**Re: Progress Report No. 26, District on the River Redevelopment  
September 2023**

Sagamore Spokane, LLC; PPCD No. 21200059-32  
Facility/Site ID #1523145 and Cleanup Site ID #3509  
Project No. 190210

**Re: Response to Ecology Comments on September 14, 2023  
Alternative Stormwater Plan**  
District on the River Redevelopment, PPCD, No. 21200059-32,  
Hamilton Street Bridge Site

**STORM WATER PLAN**

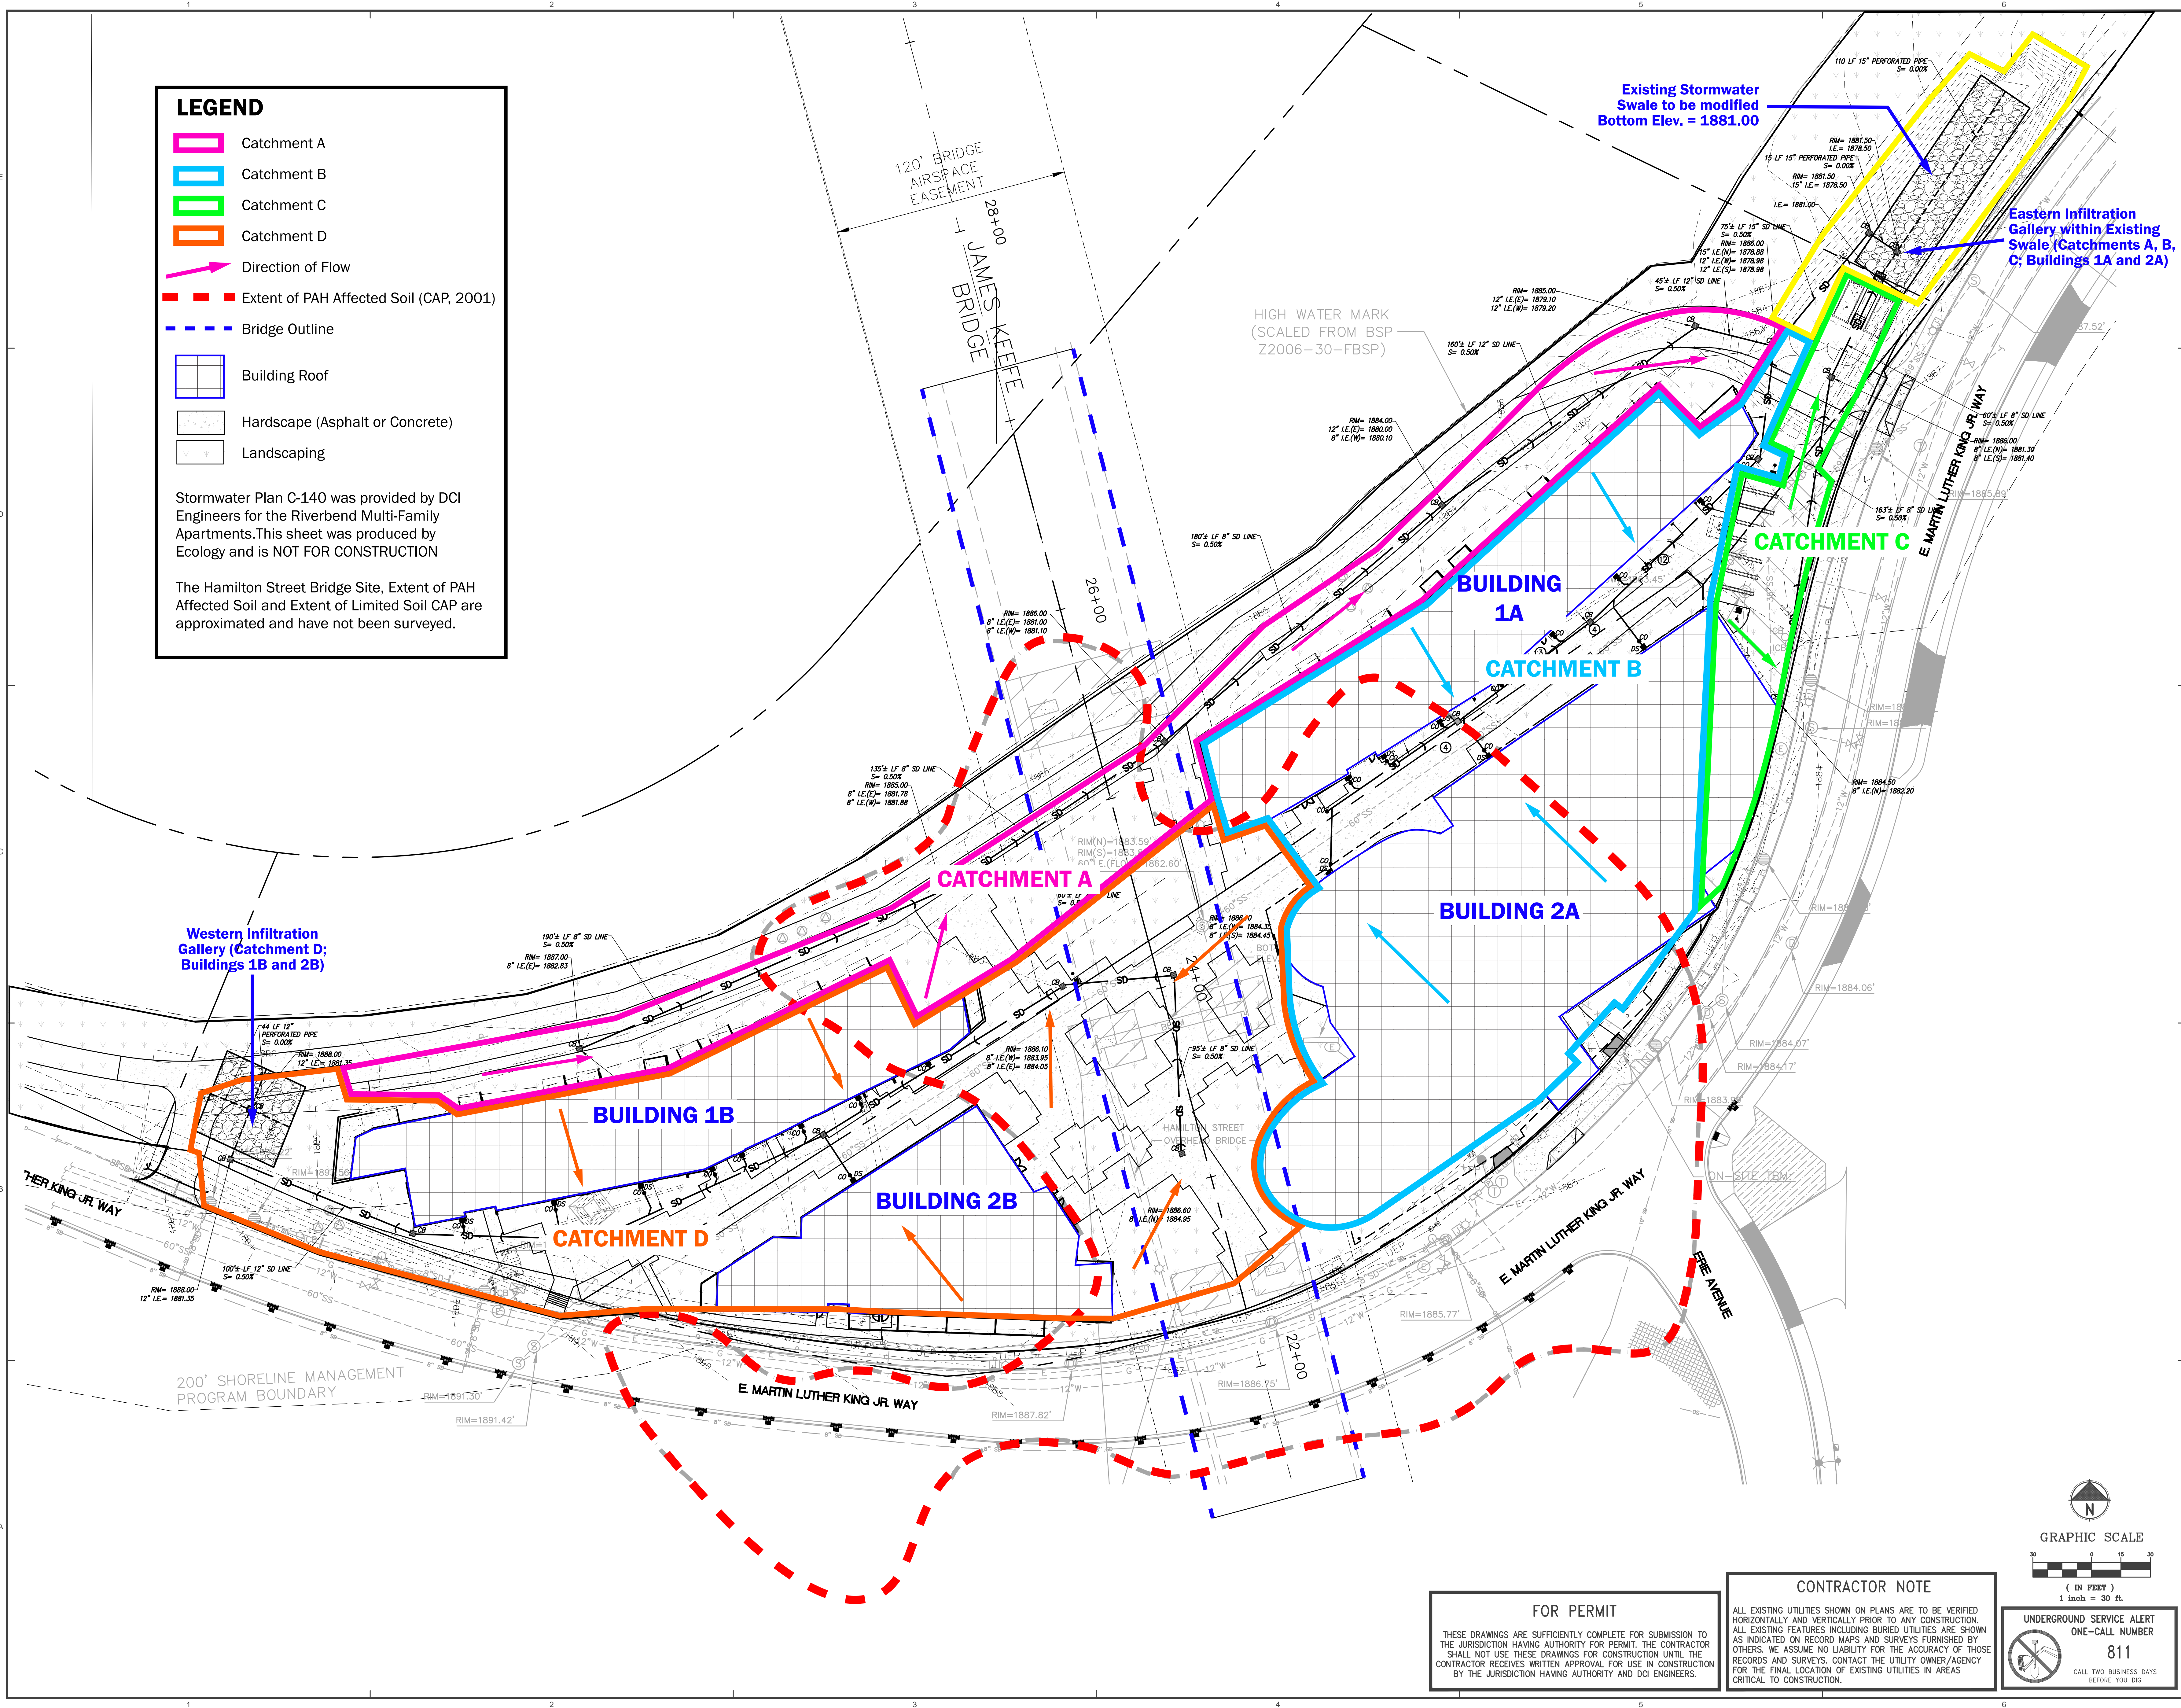
- 5) Ecology Comment on Figure. Please show the location of the pumps, the manholes into which pumped water will be discharged, and the power source locations.

- a. Aspect Response. Appendix A of the Plan documents water flow direction into nearby catch basin infrastructure. Stormwater will flow to either the west or east infiltration basins.
